GOVERNMENT OF INDIA
MINISTRY OF RAILWAYS
RESEARCH DESIGNS AND STANDARDS ORGANISATION

MODIFICATION SHEET NO.RDSO/NA44/97

MODIFICATION TO ELGI OIL PRESSURE SWITCHES (QPB)
FOR MINIMISING CRACKING OF BAKELITE BODY

SK. EL. 3268

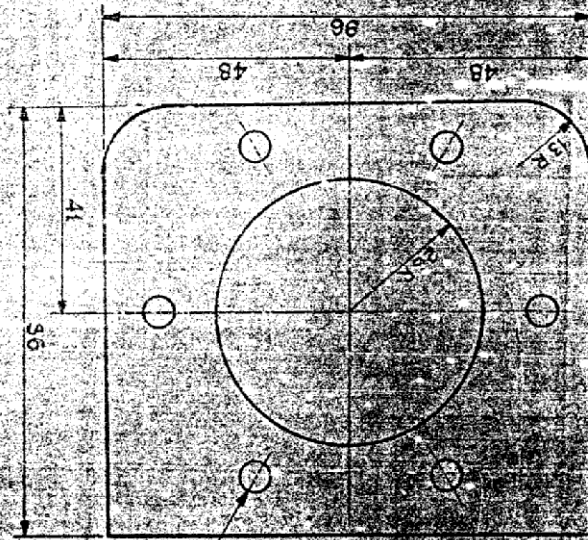
- i) One no. 0.4 mm thick, compressed asbestos fibre jointing gasket, oil resisting type grade A/O conforming to IS:2712* similar to "Permanite-oil" gasket and shall conform to drg. No. SKEL 3268.
- ii) 3 Nos. spring washers, type 'B', size M6 conforming to IS:6735** phosphate coated.

MATERIAL -
 COMPRESSED ASBESTOS FIBRE JOINTING GASKET OIL
 RESISTIVE TYPE THICKNESS 0.4 mm. GRADE A/O
 CONFORMING TO IS: 2712 SIMILAR TO PERMANITE OIL.

6 NOS. 6.2 ± 0.2 ϕ HOLES
 EQUALLY SPACED PCD
 74.5 ± 0.2
